DEVELOPMENT ASSESSMENT REPORT
Shire of Augusta Margaret River
30 April 2026 to 6 May 2026

DEVELOPMENT APPLICATION ASSESSMENT P225980

Address	44 Willmott Avenue, Margaret River			
Proposed Development	Ancillary			
Zoning	Residential – R15			
Lot Area	794m ²			
Use Class and Permissibility	'P' – Permitted Use			
Heritage/Aboriginal Sites	None identified			
Other Considerations	Visual Management Area	<input type="checkbox"/>	Sewerage Sensitive Area	<input type="checkbox"/>
	Special Control Area	<input type="checkbox"/>	Watercourses/Rivers	<input type="checkbox"/>
	Bushfire Prone Area	<input type="checkbox"/>	Environmentally Sensitive Areas	<input type="checkbox"/>
Structure Plans/LDP's	None			
Easements/Encumbrances	None			
Why is Development Approval Required?	Application varies R-Codes clause 5.1.3 Lot boundary setbacks

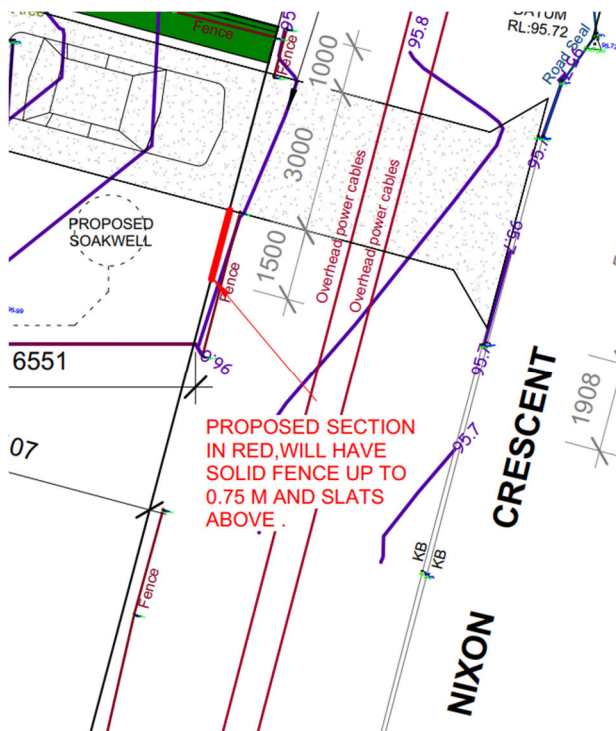
The deemed-to-comply standard requires walls, fences and other structures be truncated or reduced to no higher than 0.75m within 1.5m of where they adjoin a driveway.

The proposed fencing along Nixon Crescent, within 1.5m of where it adjoins the driveway, is noted on the plans as being a solid fence up to 0.75m with slats above. As this is the second crossover for the property, compliance with this clause will be ensured through a condition of permit. The slats indicated on the plans do not pose an issue so long as visual permeability is maintained, by providing a sufficient distance between the solid slat components.

- a) The location, name and mature heights of proposed trees, shrubs and ground covers on both the subject site; and
 - b) Planting schedule/timing.
5. Fencing along Nixon Crescent is not to be solid above 0.75m above natural ground level within 1.5m of the ancillary driveway. Any fencing above 0.75m in height must be visually permeable, to the satisfaction of the Shire.

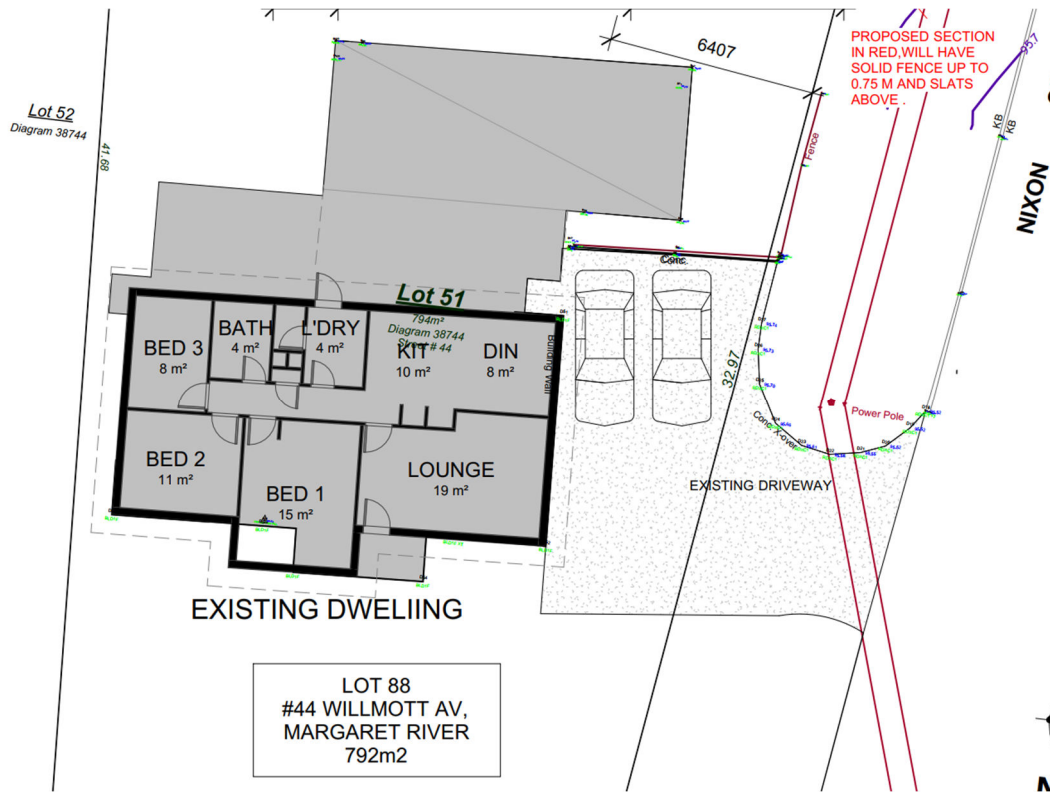
Clause 5.3.5, C5.2 requires 'no driveway wider than 6m at the street boundary and driveways in aggregate no greater than 9m for any one property'. The proposal includes a secondary crossover towards the rear of the property, to provide the required parking bay for the ancillary. The proposed crossover/driveway is 3m in width, so it in itself is compliant. However, the application varies the maximum 9m driveway aggregate. The existing driveway is approximately 11.19m in width at the property boundary and 6.98m in width where it meets the street.

The existing crossover is larger than deemed-to-comply standards as it combines a driveway and vehicle parking area. As can be seen in the below excerpt from the site plan, the driveway area is

constructed so that vehicles park parallel to the street, thus necessitating a larger area than if it was purely a driveway.

Whilst the design principle aims to reduce the number of crossovers, two crossovers is necessary in this instance to provide the required number of carparking bays, which are two (2) for the main dwelling and one (1) for the ancillary.

The size of the driveways is acceptable in this instance, and given the size of the driveways individually, no additional landscaping features are required.
